From: Julie Grieves on behalf of Planning.Responses
Sent: 02 April 2019 09:29
To: Planning Scanning
Subject: FW: Application ref EP/23/19/HH
Attachments: Responses to objections.docx; Sheet 2 rev 3.pdf; Sheet 1 rev 3.pdf; Sheet 3 rev 3.pdf; Sheet 4 rev 3.pdf

Ref EP/23/19/HH

Responses to objections

Proposed Car/Caravan port
 43, Sea Lane , East Preston
 BN16 1NE
 Sheet 1
 Dimensions in mm
 Date- 19th February 2019
 Drawn- Paul Haymes

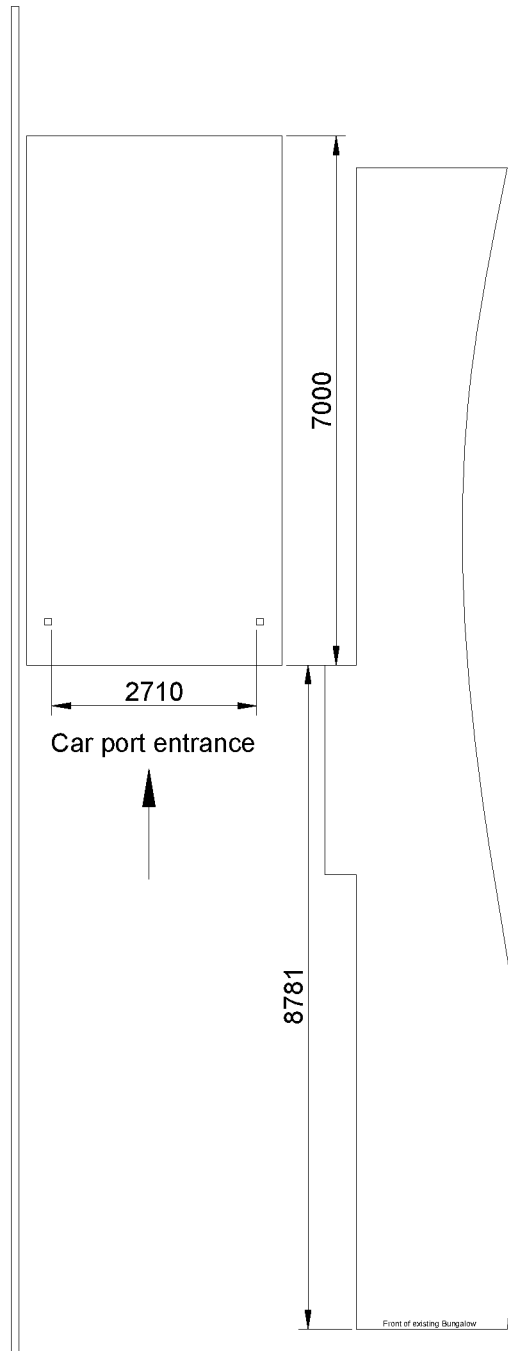
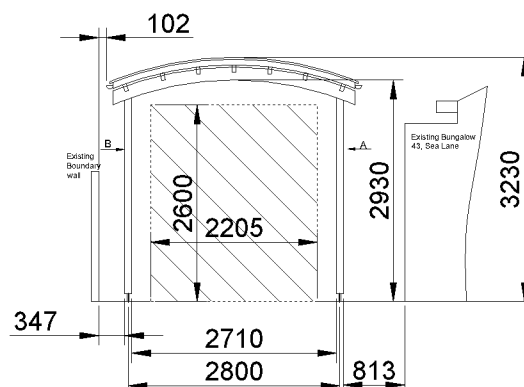
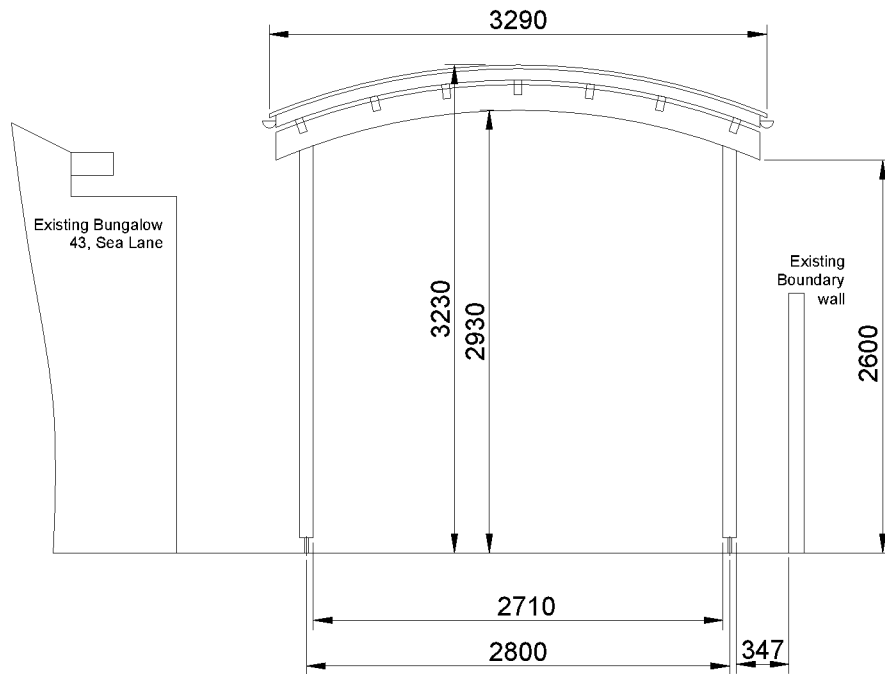
Item 6 – The pillars are now 347 mm inside the Boundary wall (please note this is a boundary wall not a party wall and is owned by no 43) The structure has been repositioned on the drawings. However, it is worthy of note that Mr Mc Naughton has erected a 2.5m high trellis, with planting, the supporting posts of which are approximately 100mm from the boundary wall.

Item 7 – Noted and as mentioned above this has now been moved and the overall width of the structure reduced.

Revision 1-Detail added - 27/2/19
 Revision 2 - Dimension of opening
 added to plan view -2/03/19
 Revision 3 -Dim 347 was 260. Dim 102
 added. Caravan shown in red. Other
 dim added, Pictorially altered for clarification - 30/03/2019

Proposed Car/Caravan port
 43, Sea Lane , East Preston
 BN16 1NE
 Sheet 2
 Dimensions in mm
 Date- 19th February
 Drawn- Paul Haymes

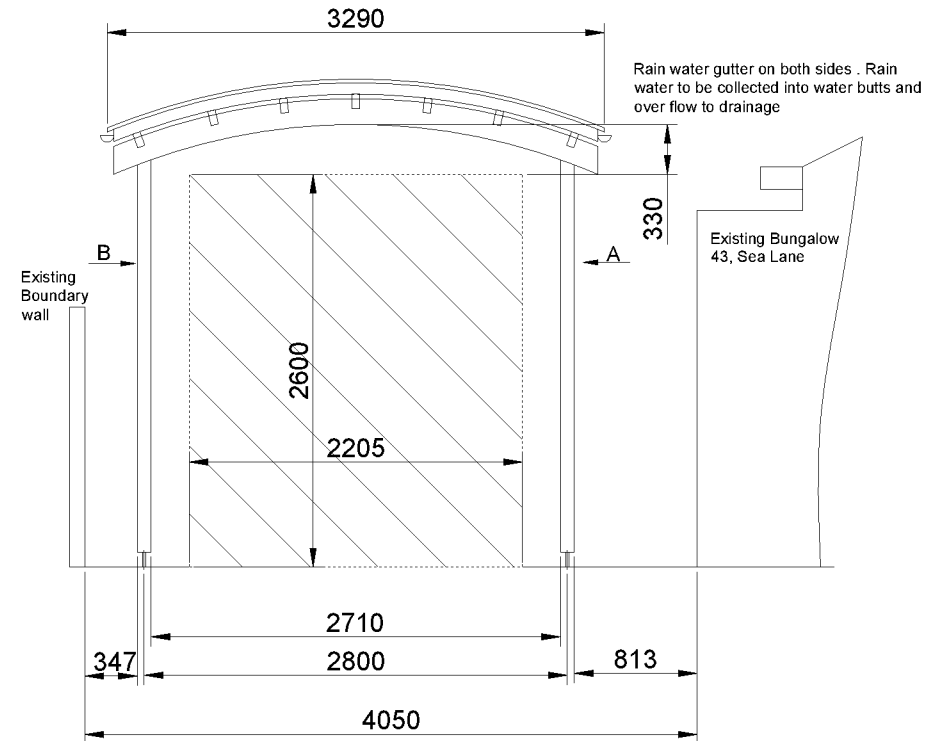
Item 9- It is noted that the edge of the roof is close to the boundary wall and the drawings have now been amended to move the structure further away from the boundary wall.

ITEM 8- Gutters are shown on the drawings however a note has now been added to the effect that all rain water will be taken away into suitable storage water butts for use and any excess water will be drained away. No water will be allowed to pass over the wall into neighbouring property.

Revision 1-Detail added - 27/2/19
 Revision 2 - Dim 3230 was 3205
 Extra dimensions added .
 Revision 3- Extra Dim's added, dim 347 was 280
 Caravan shown in red hatched. Rainwater note added
 Dim 3290 was 3450
 Drg pictorially altered - 30/03/2019
